GOVERNMENT OF THE DISTRICT OF
COLUMBIA DEPARTMENT OF GENERAL
SERVICES

CONSTRUCTION SERVICES FOR ENGINE HOUSE NO. 2 RENOVATIONS AND
UPGRADES

Solicitation Number: DCAM-19-CS-IFB-0005

Addendum No. 3

UPDATED DESIGN DETAIL FOR CAPTIVE AIRE HOOD

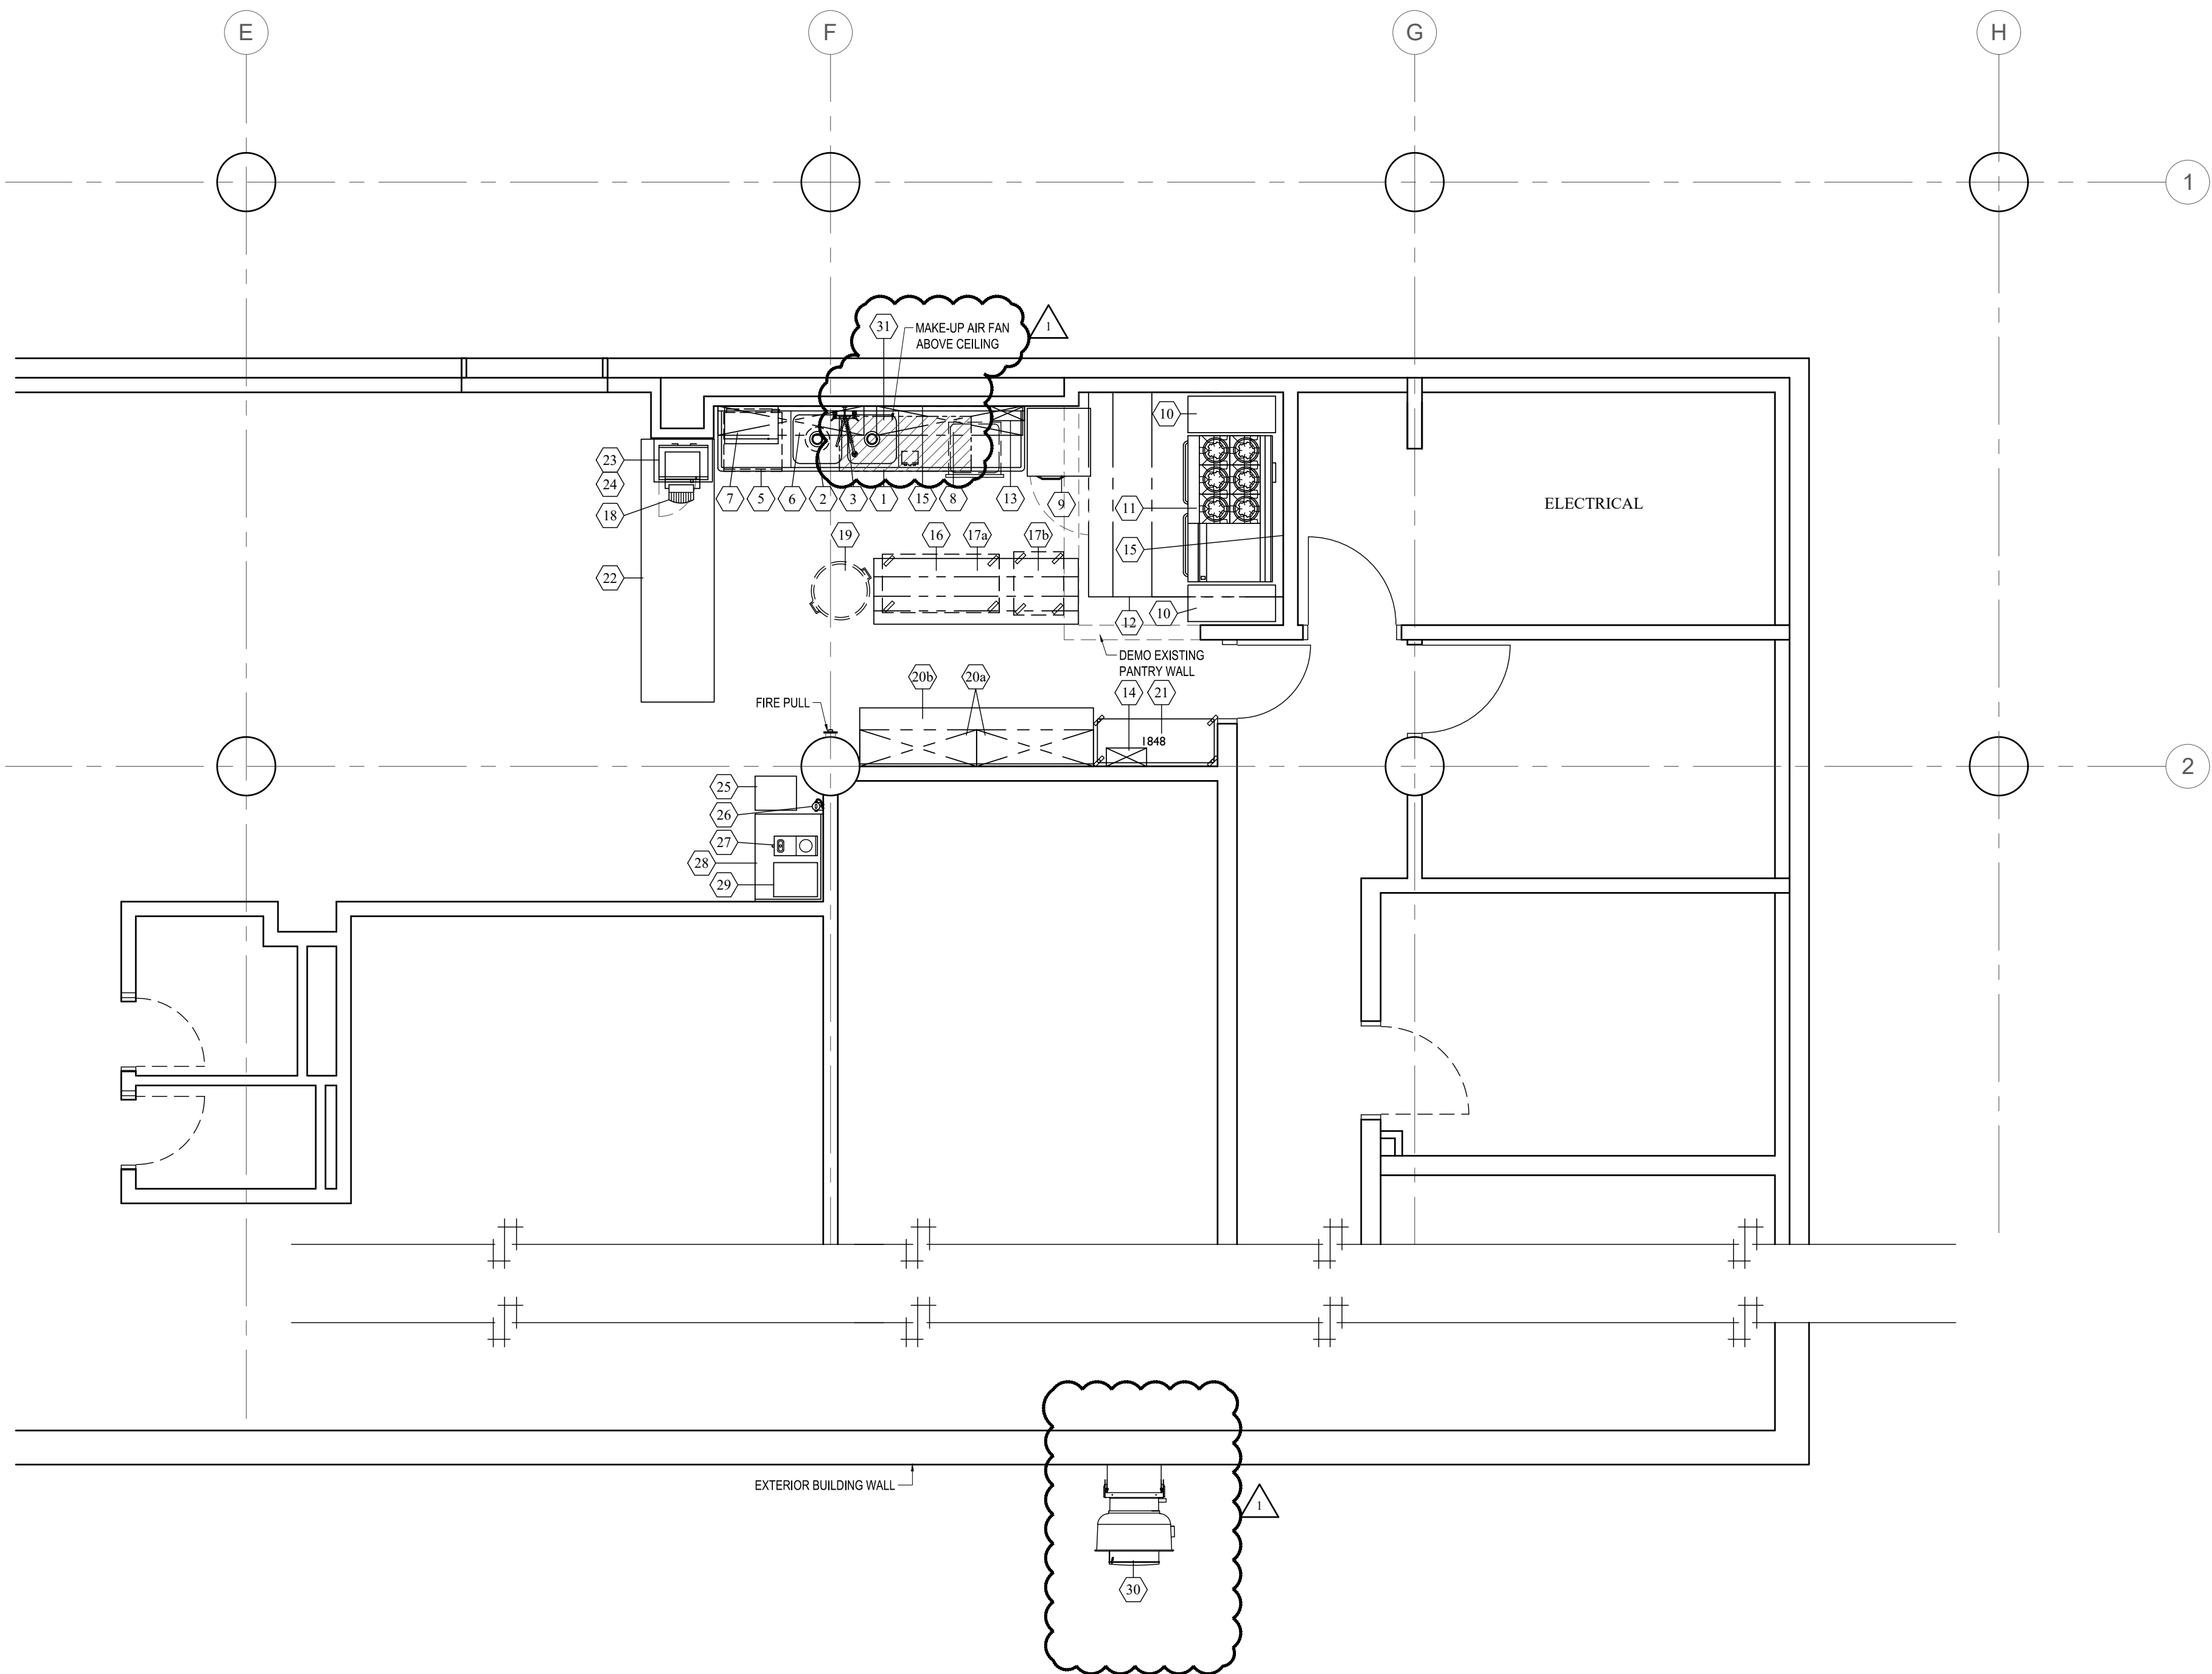
Item #4: Captive Aire Hood and Kitchen Exhaust & Make up Air Plan: The updated Design detail for Captive Aire Hood (**Exhibit 2**) as per revision dated June 13, 2019, and Kitchen Exhaust & Make up Air Plan (**Exhibit 3**) as per revision dated June 11, 2019 are attached.

ELECTRICAL
CONNECTION
PLAN

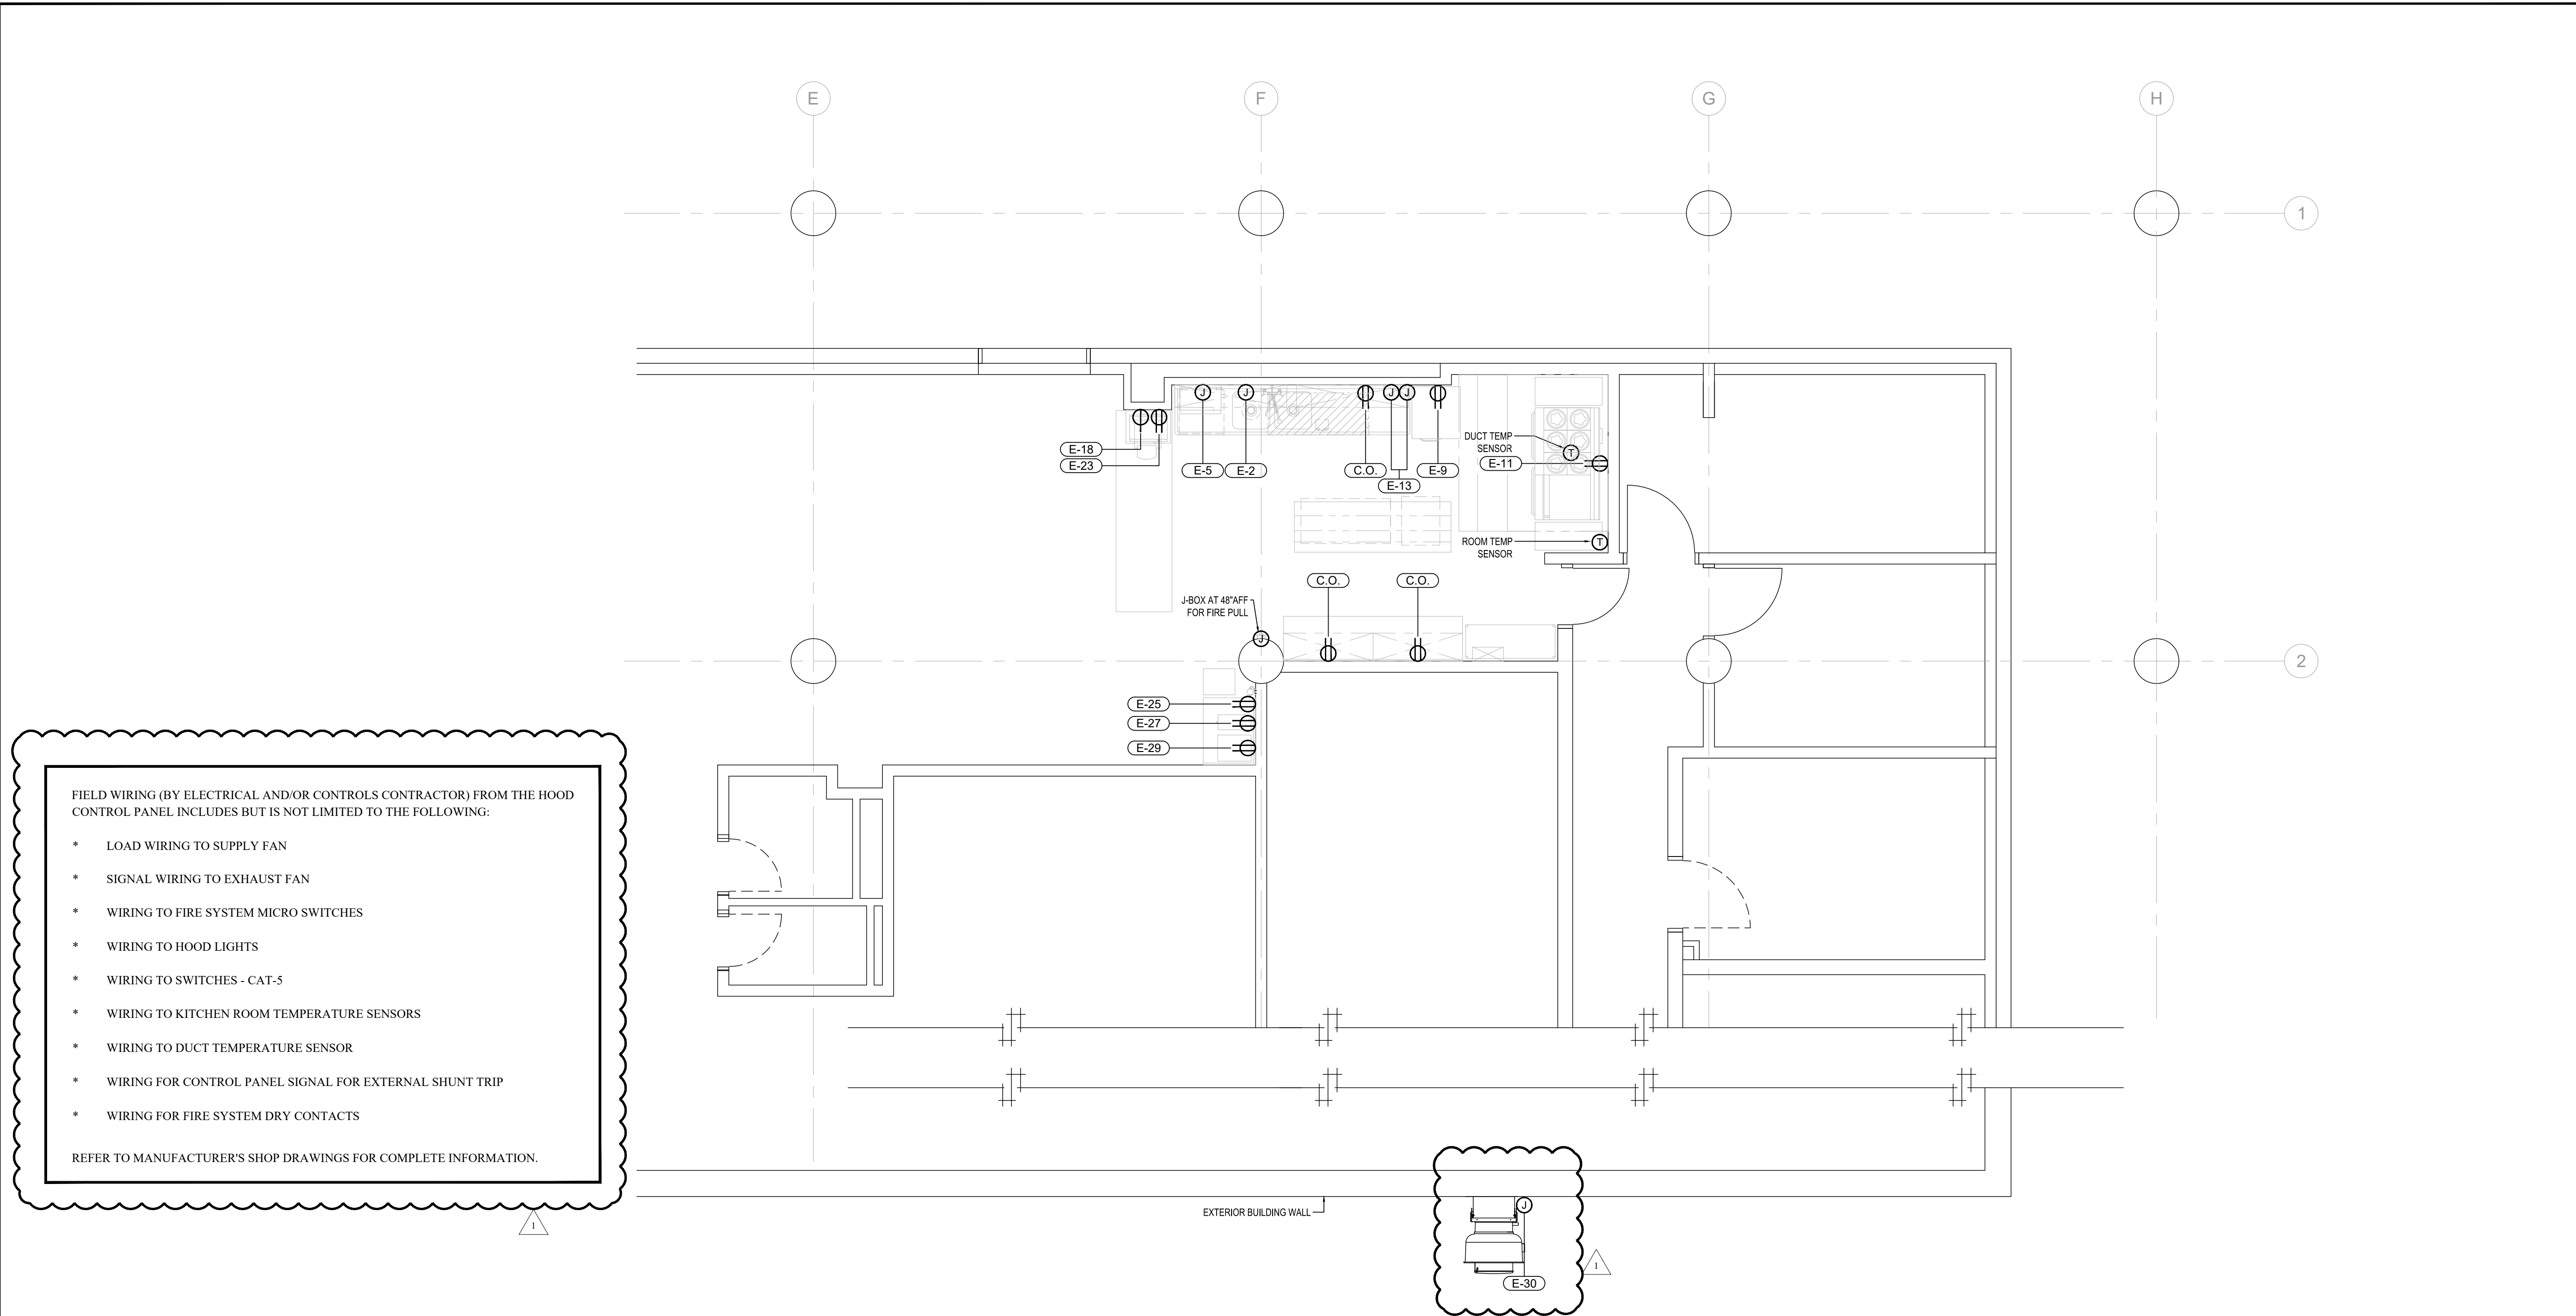
5	Please reference Dwg. K-3 (Electrical Connection Plan). The extent of electrical work as far as demo is unclear. For instance, the items that are listed as existing (ie, microwave oven, water dispenser, etc.) in the schedule appear to show a new receptacle as per the connection plan. Please confirm that we should include removal of existing receptacles and provide new receptacles as per the plan and schedule.	Confirmed.
6	In Addendum No. 2 the drawings in Exhibits 2 and 3 are too blurry to read. Please resubmit the drawings.	Please see attached.
7	A CBE commercial drywall/acoustical contractor and interested in expanding into more general contracting. Have worked on dozens of DGS projects, mostly schools and libraries, over the last eight years or so as a subcontractor. Wanted to find out if there is anything we should do ahead of time (i.e., is there some sort of prequalification process?). We are confident that we have the capability to do this type of work, but are just not familiar with the procedures.	See DGS RFP contractor requirements.
